**NOTICE TO BIDDERS D
HARBOR-UCLA MEDICAL CENTER REPLACEMENT PROGRAM
GENERATOR BUILDING RETROFIT PROJECT COMPONENT
BID NUMBER: BRC0000569
SPECS 7962; C.P. 67961**

April 16, 2025
REQUEST FOR INFORMATION/CLARIFICATIONS
HARBOR-UCLA MEDICAL CENTER REPLACEMENT PROGRAM
GENERATOR BUILDING RETROFIT PROJECT COMPONENT
BID NUMBER: BRC0000569

EXHIBIT 14 - Addendum D

1. Addendum D Narrative: Prepared by RBB Architects dated April 11, 2025

DU2-004

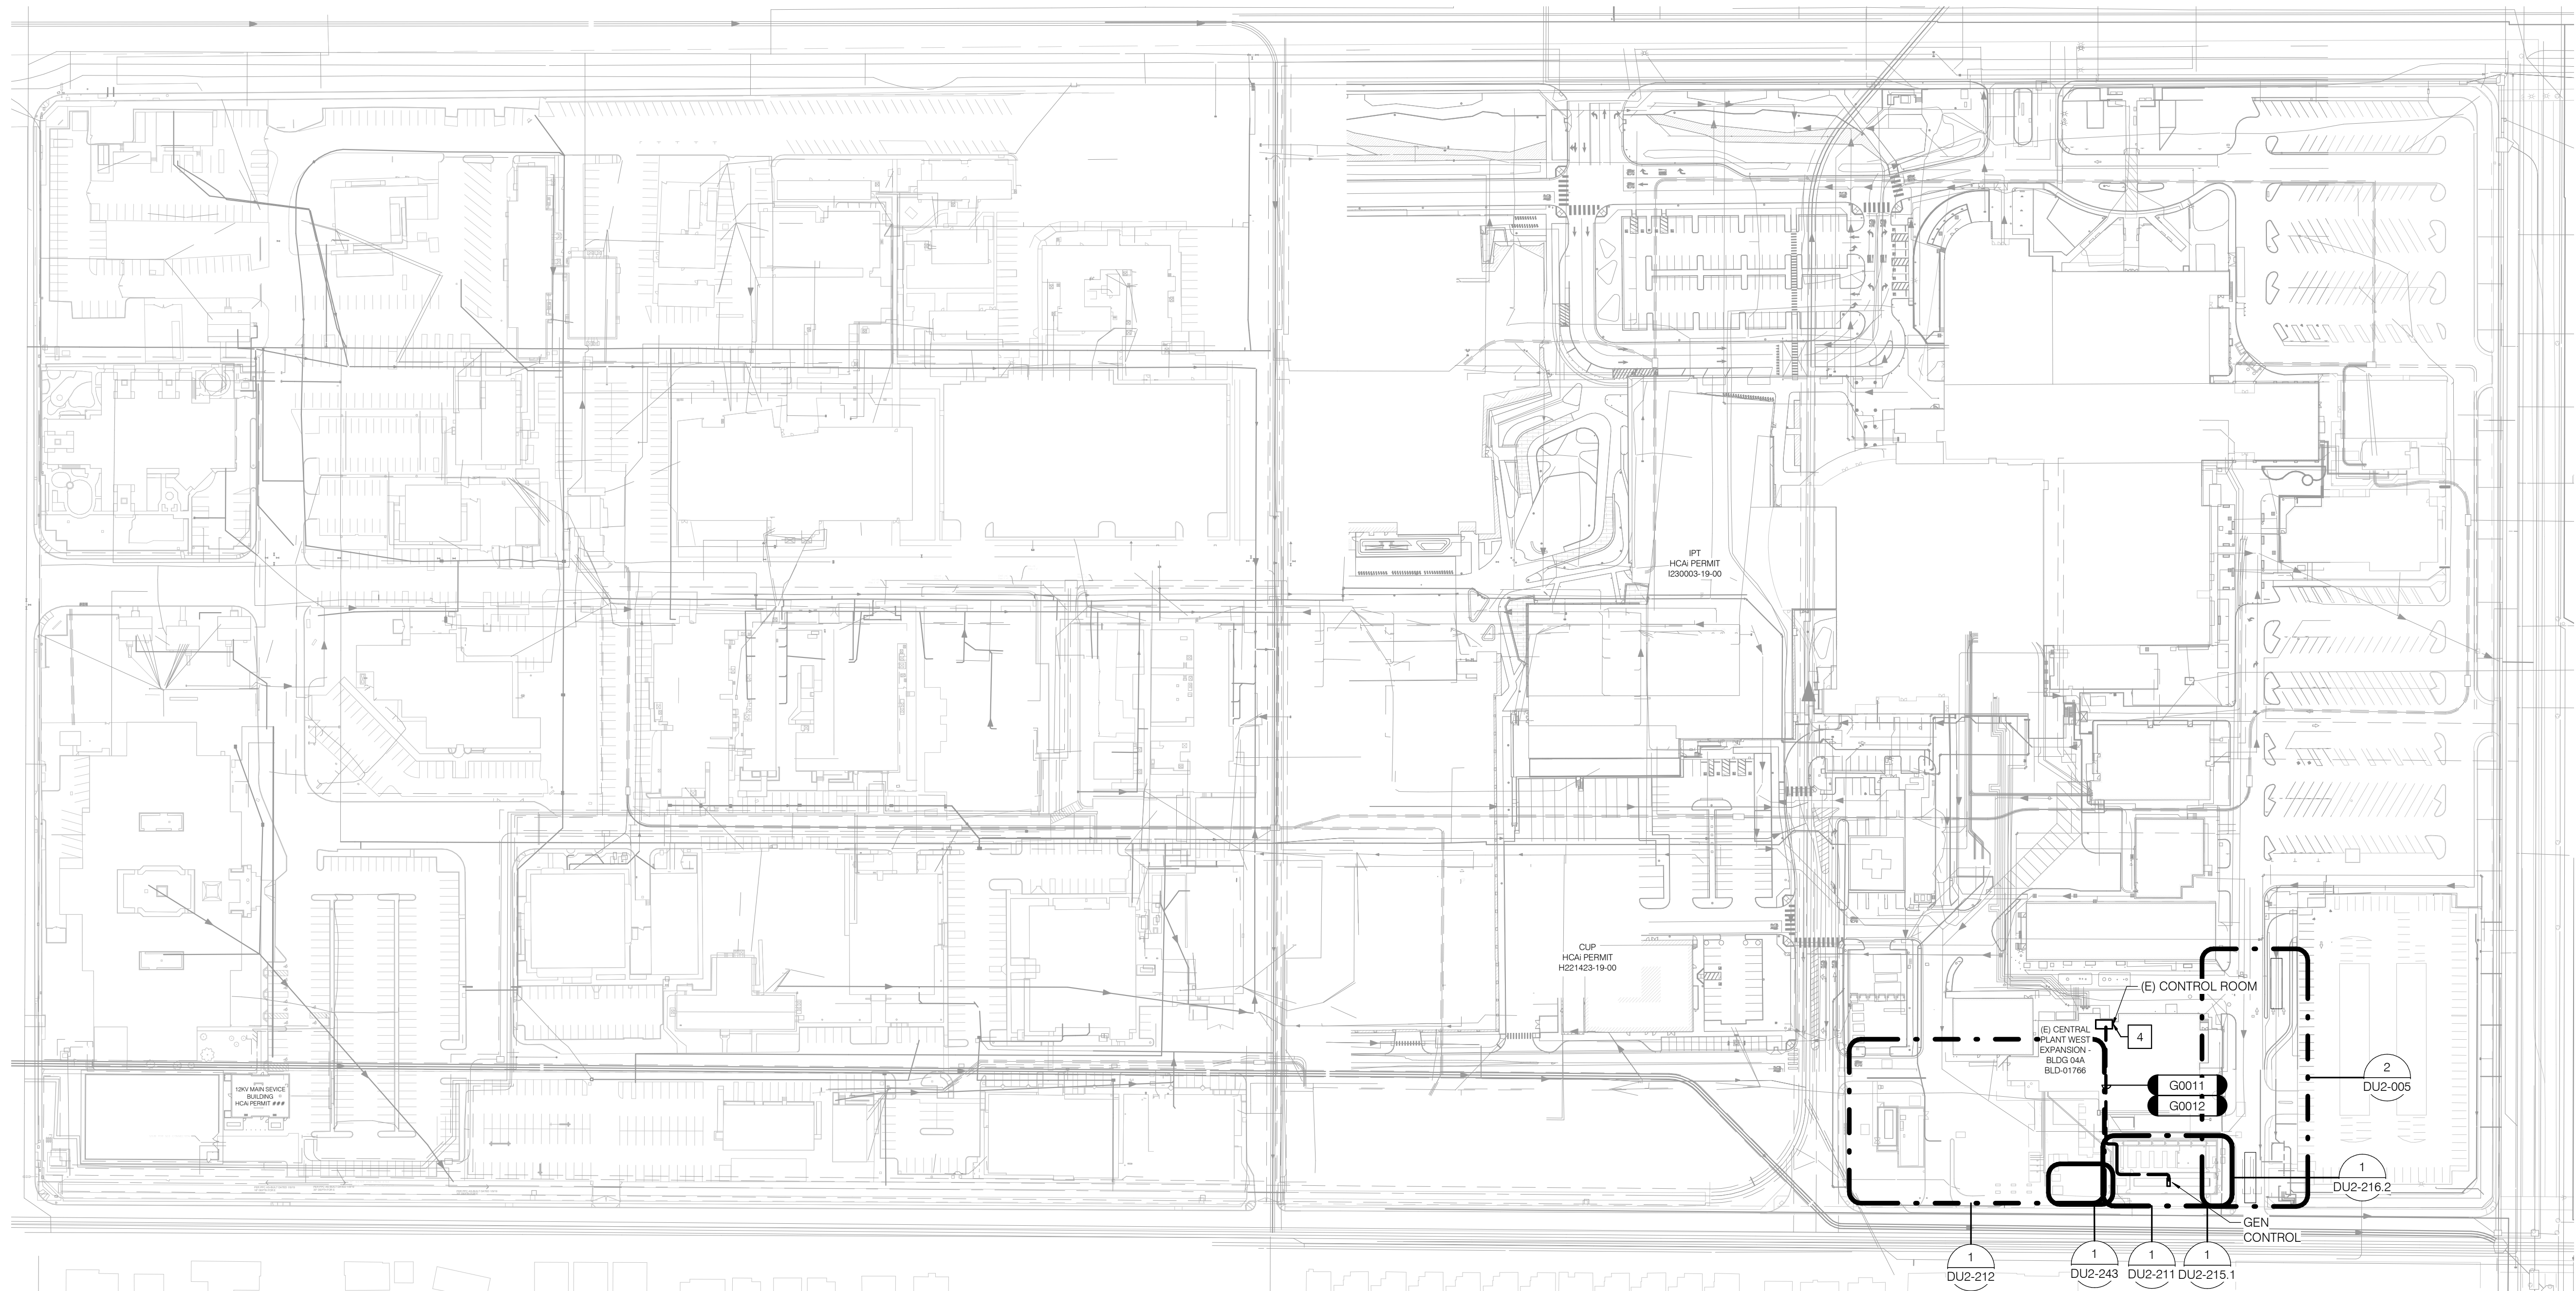
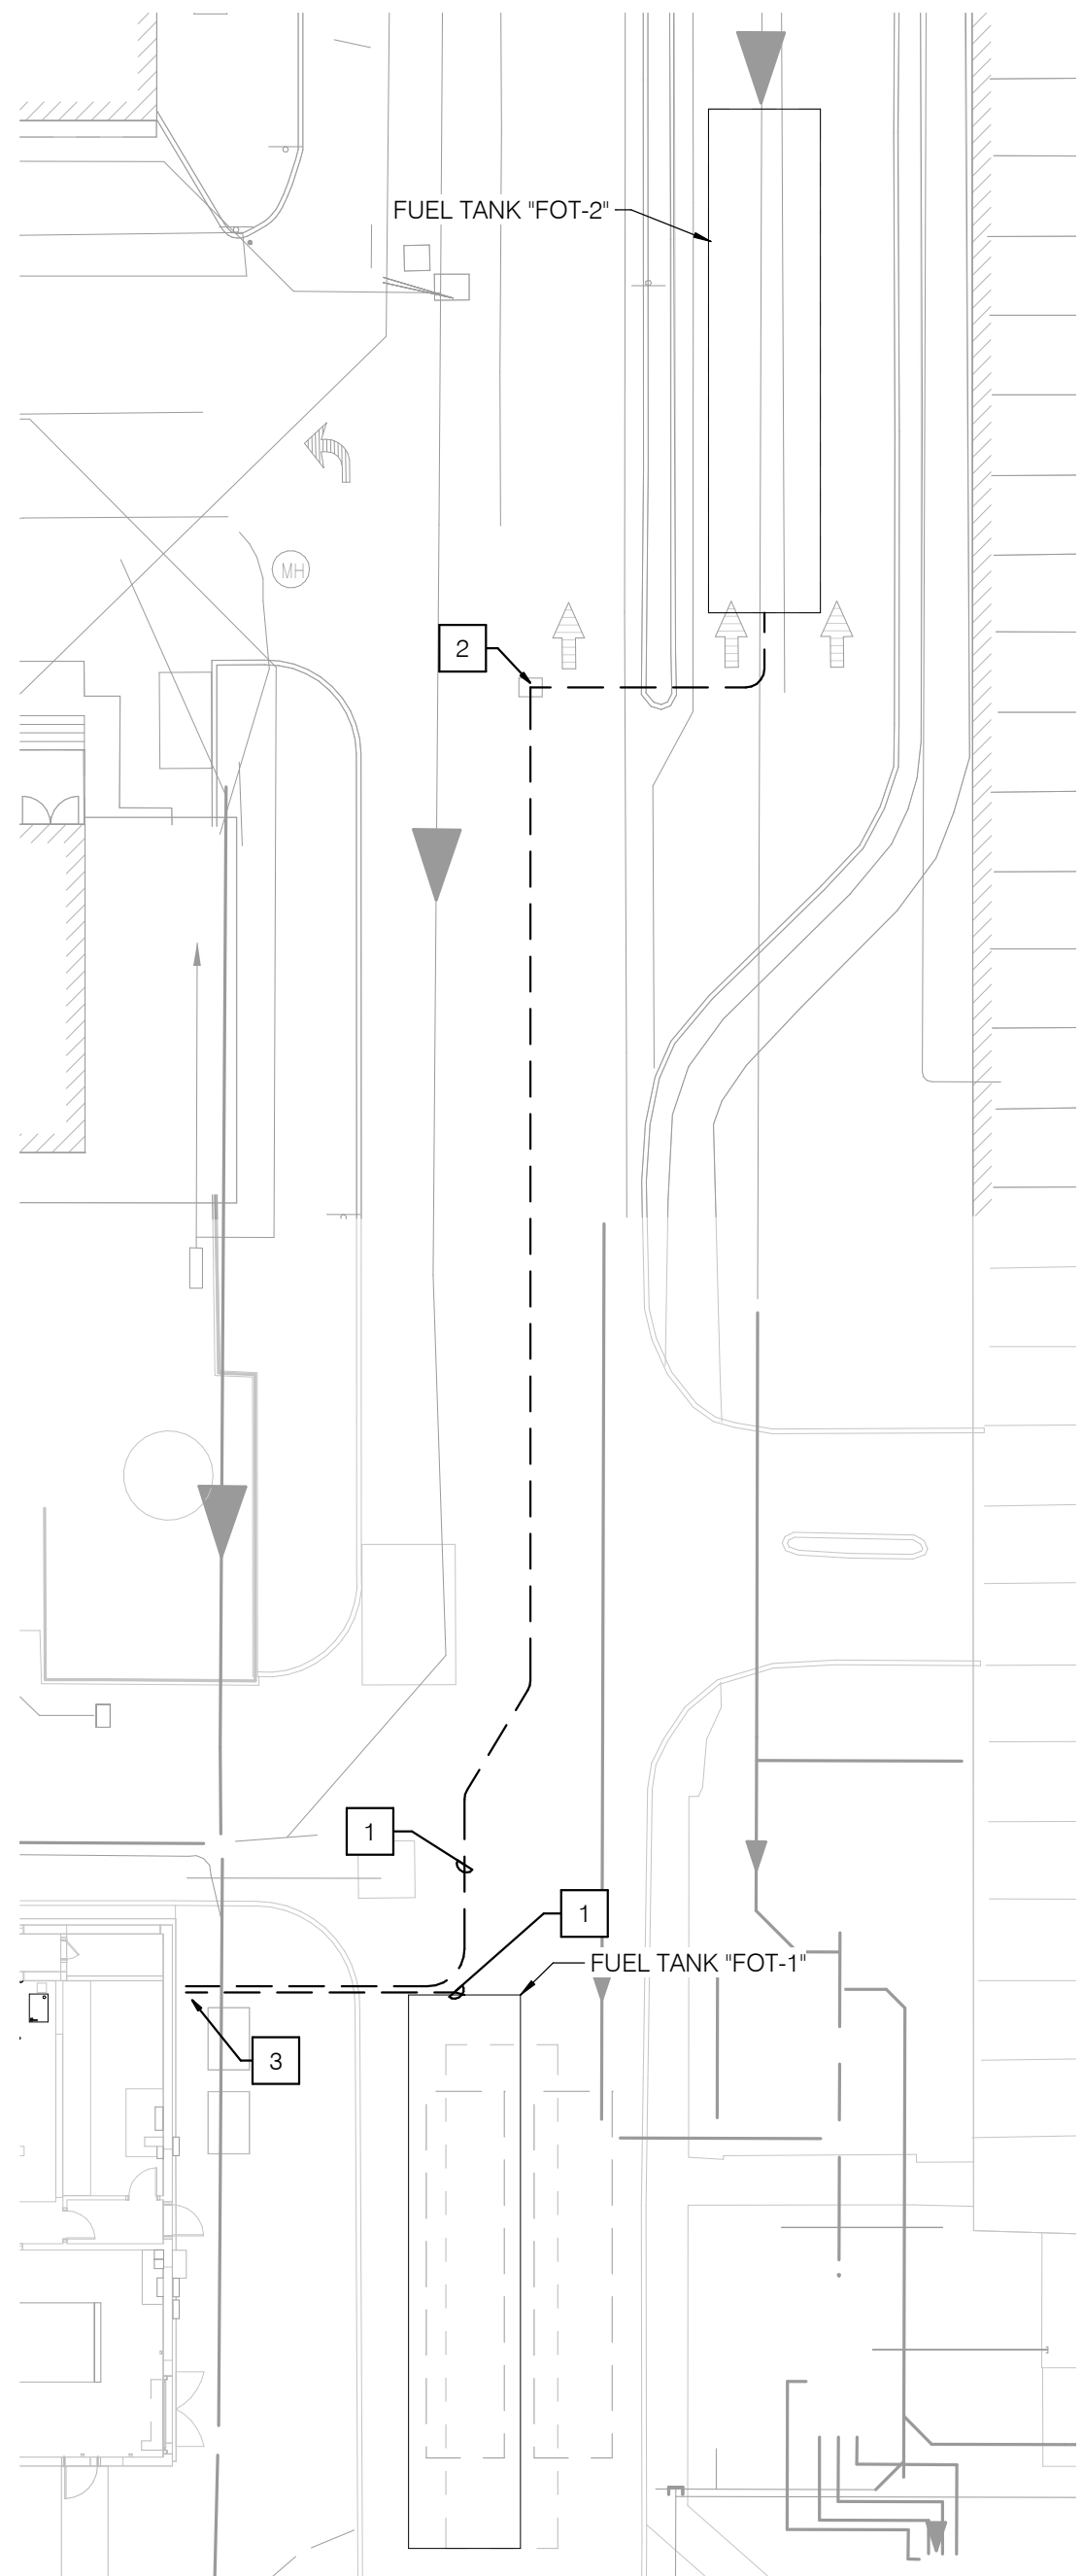
- DU2-004** – Added general notes to provide additional requirements for contractor.
- DU2-004** – Updated feeders to fuel pumps on Note 1.

DU2-215.1

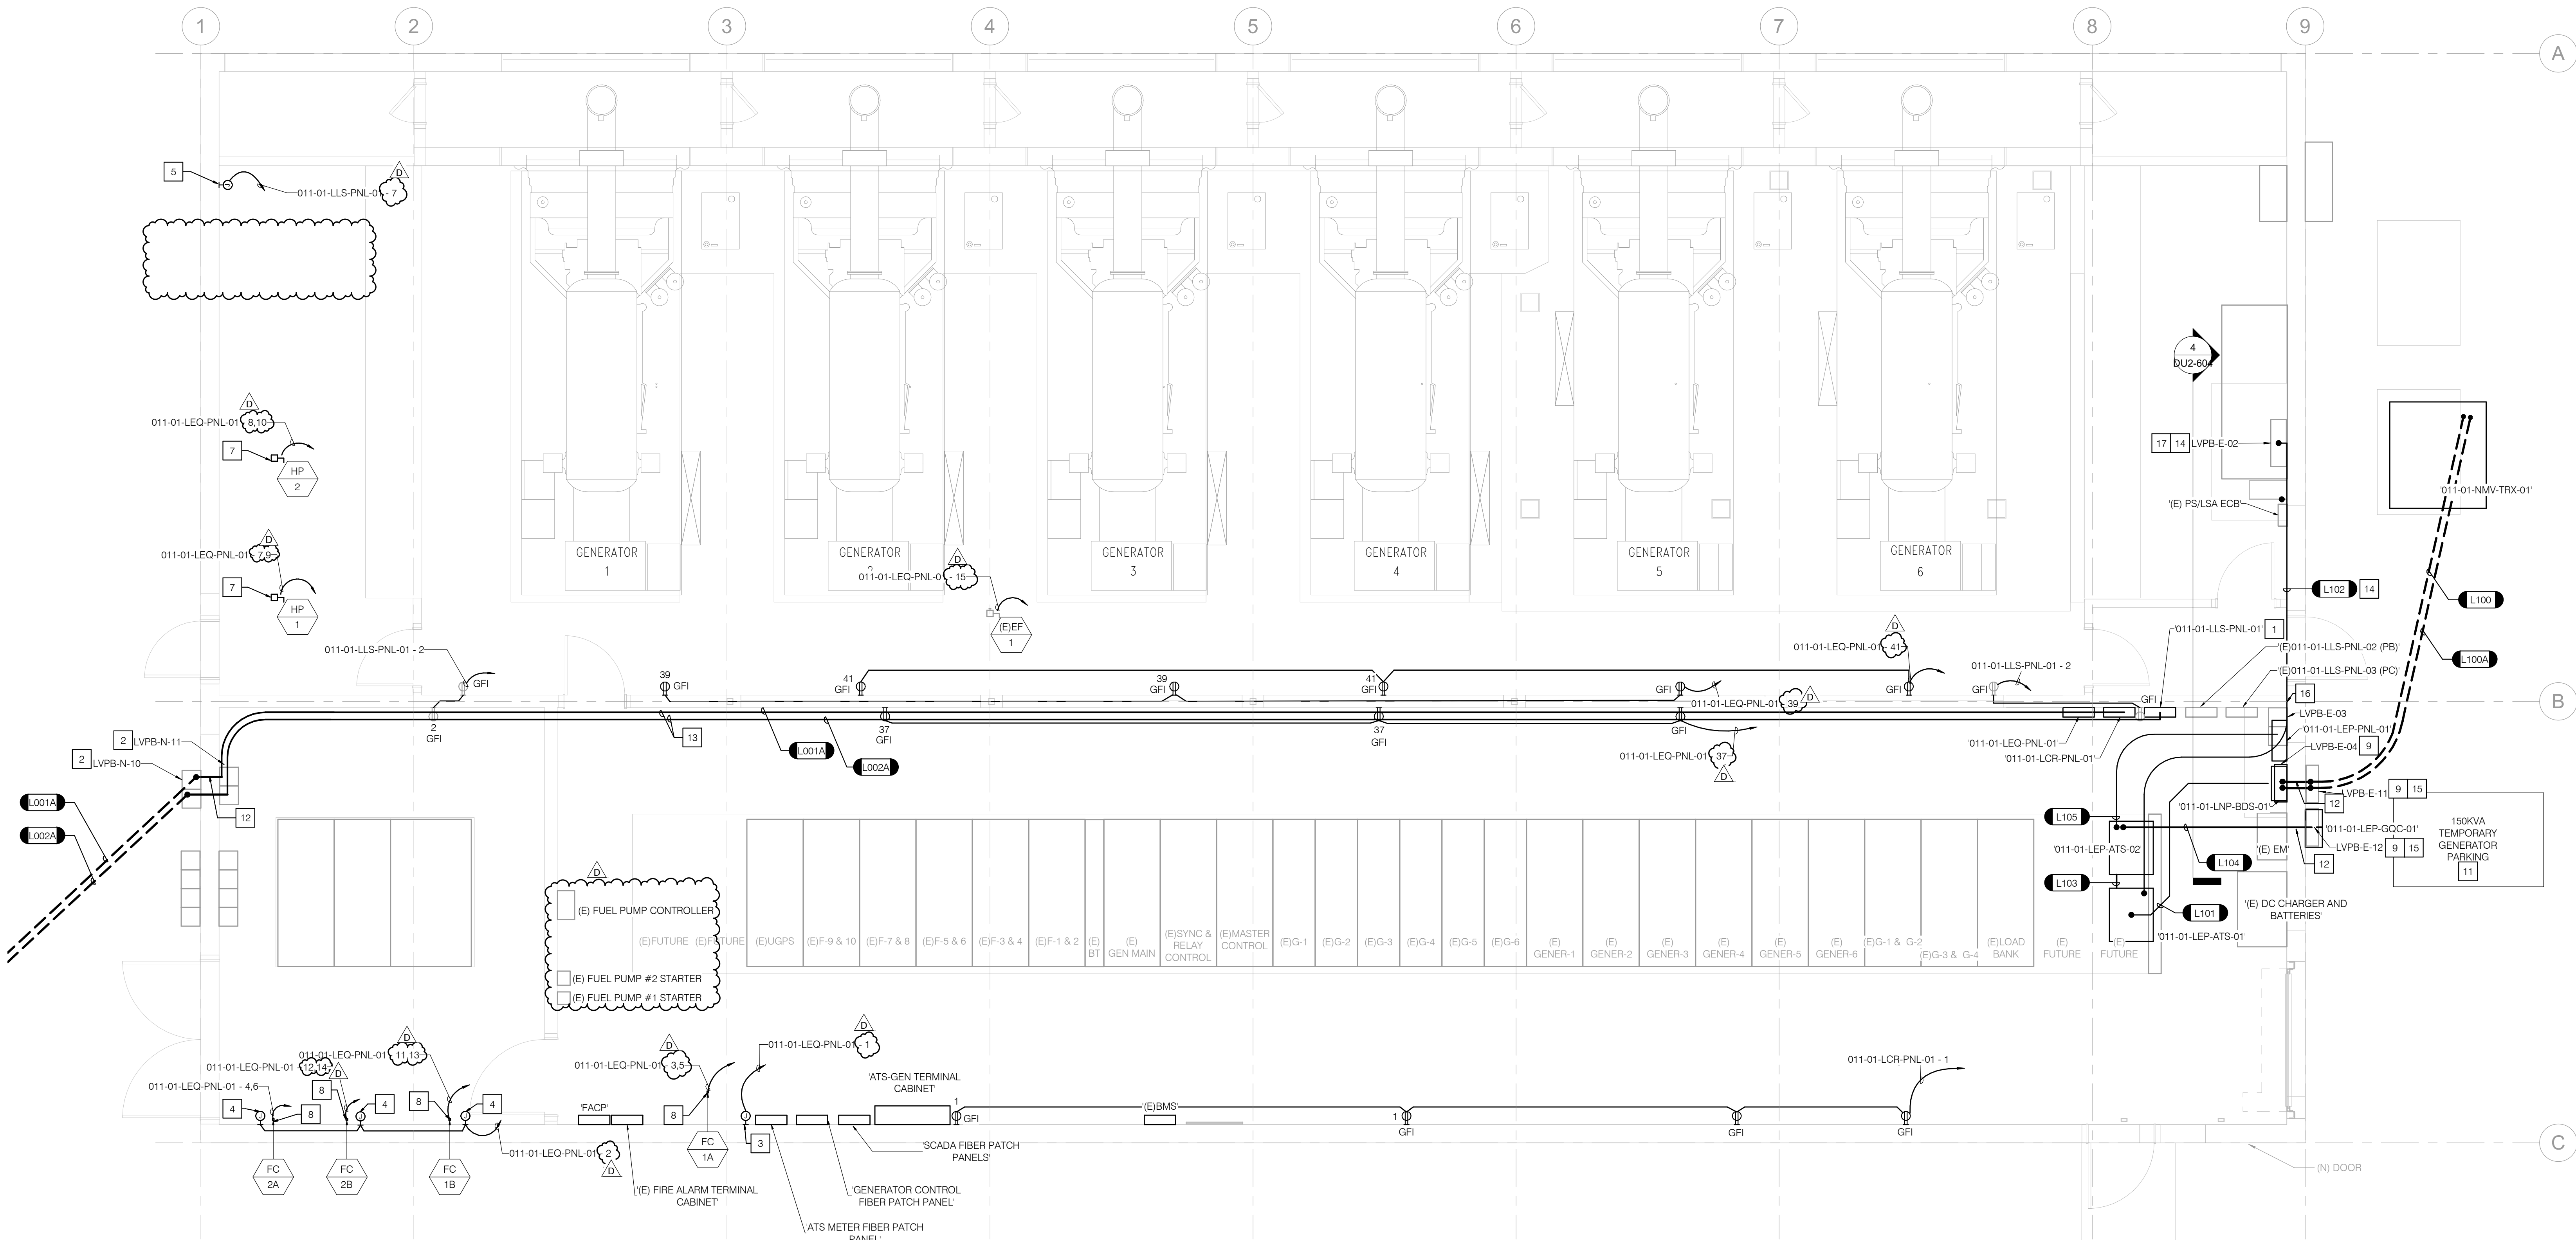
DU2-215.1 – Added existing starters and pump controllers. Added Note 4 for demo instructions.
